Access Compliance Report Public Rights-of-Way (Curb Ramps)

Main Street: WESTFORD_RD		Cross Street: STRATHMORE		Location:	N
ADA ID: RPAT211103153540	Ramp Type: Type 4 - Parallel	Initial Pass/Fail: Fail	Overall Compliance: No	Severity Score:	16
Codes/Mitigation Info/Possible Solution			Field Measurements/Component Compliance

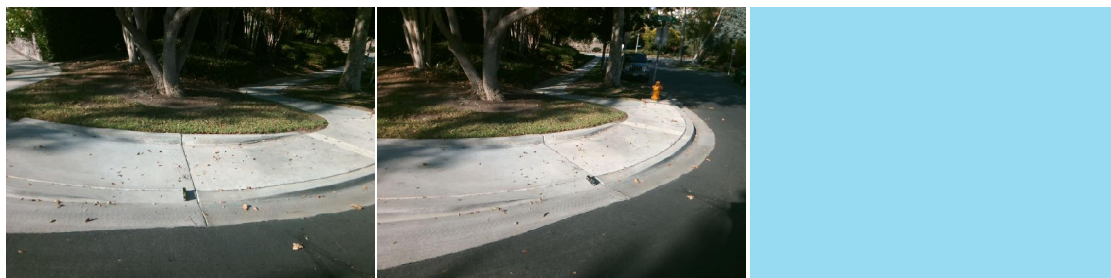
R204.3, R304.3.2, R304.5.3, STD 1115

Remove & Replace Curb Ramp With Two New Directional Ramps or Equivalent.
